August 9, 2013  
ES/NRC 13-017  
Docket No. 71-9168

**Subject: Response to Request for Additional Information for the Model No. 8-120B Package, Docket No. 71-9168**

Reference: Letter from P. Saverot (NRC) to S. Sisley (EnergySolutions), "Request for Additional Information for the Model No. 8-120B Package, Docket No. 71-9168," July 15, 2013, ADAMS Accession Number ML13197A036.

Figure 5-3 - Payload Gamma Source Strength Limit vs. Gamma Energy

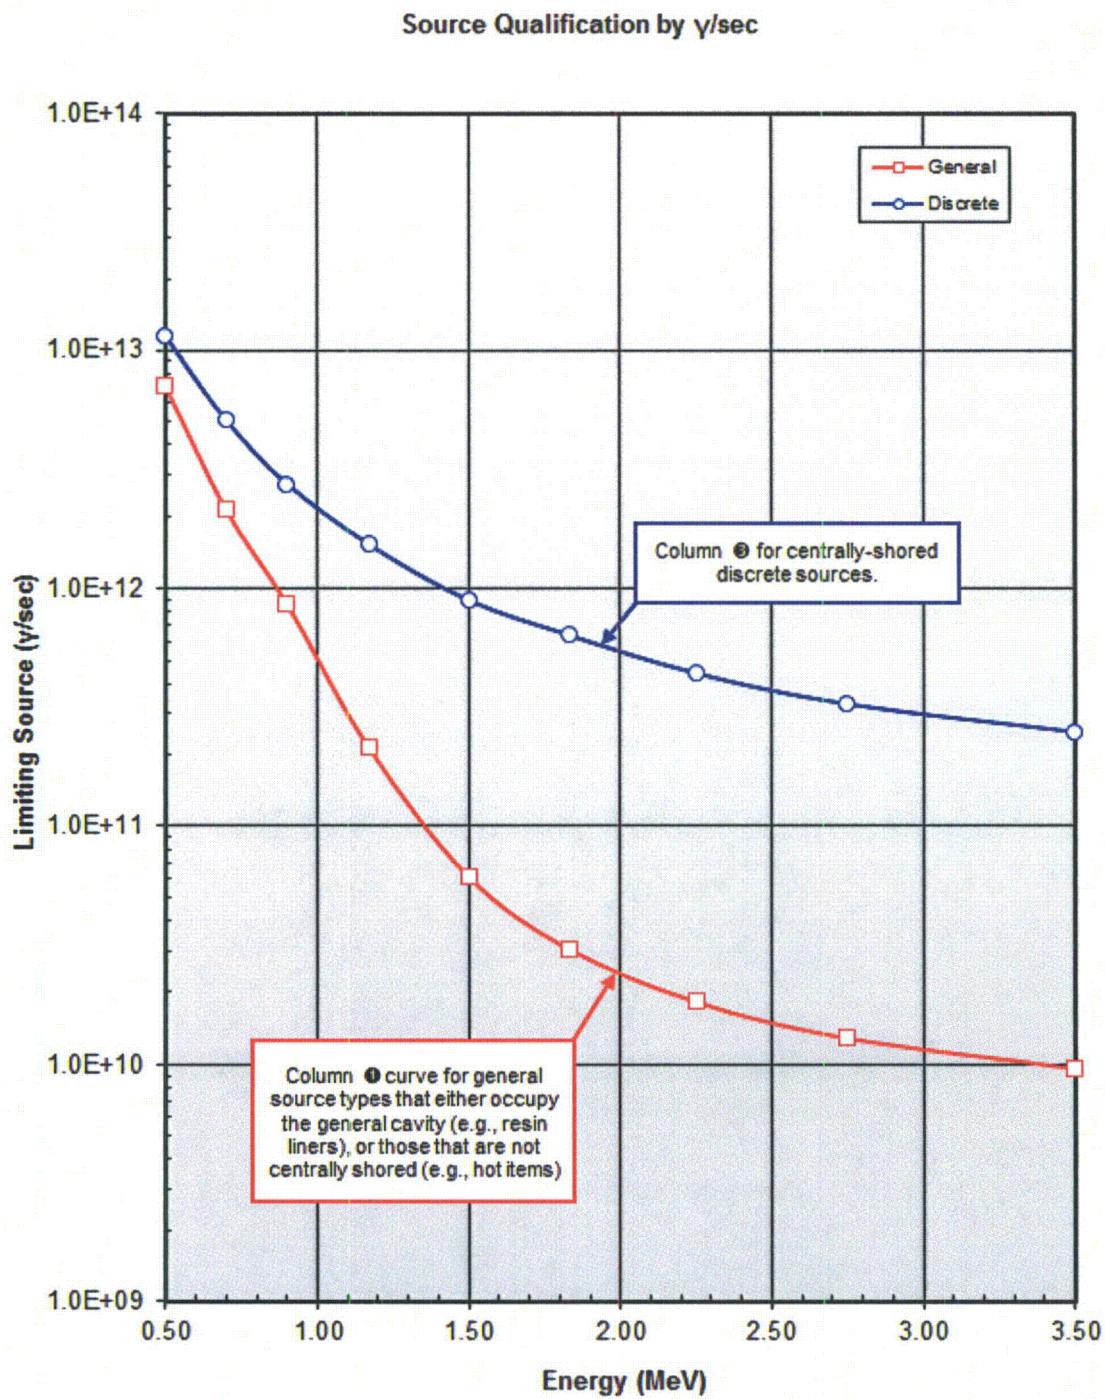
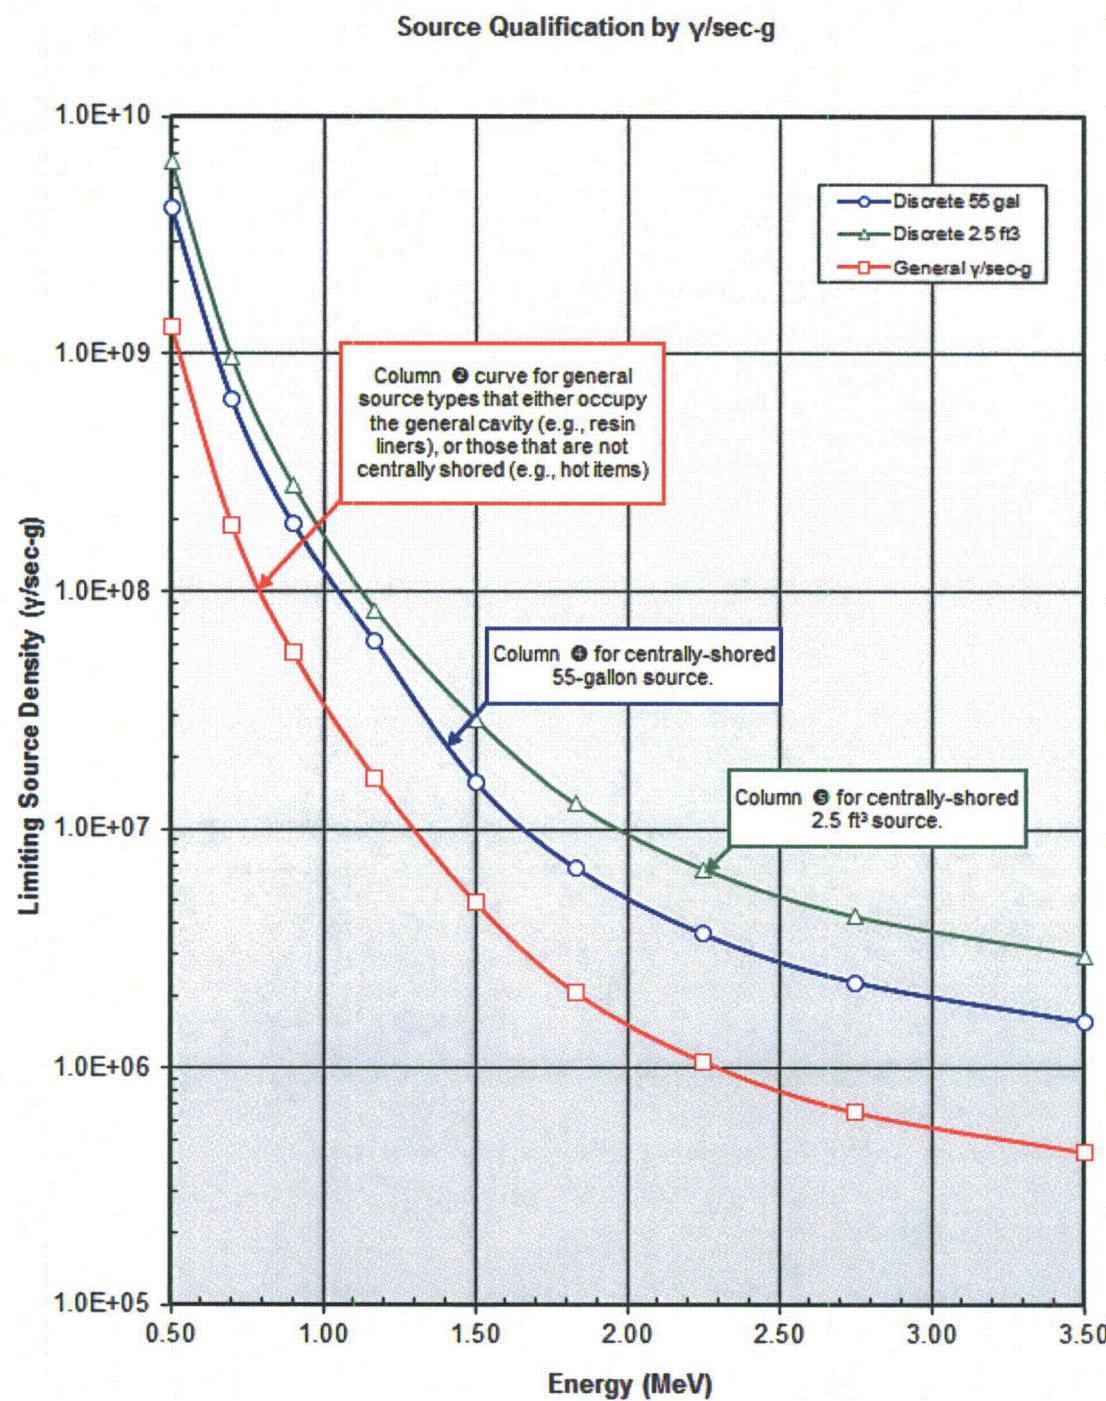
- The dose rates presented in Table 5-1 are updated to reflect the revised shielding analysis.
- The payload source limit results presented in Table 5-5 and in Figures 5-3 and 5-4 are updated to reflect the revised shielding analysis.
- Table 1 and the examples in Chapter 7 are updated to reflect the revised shielding analysis.
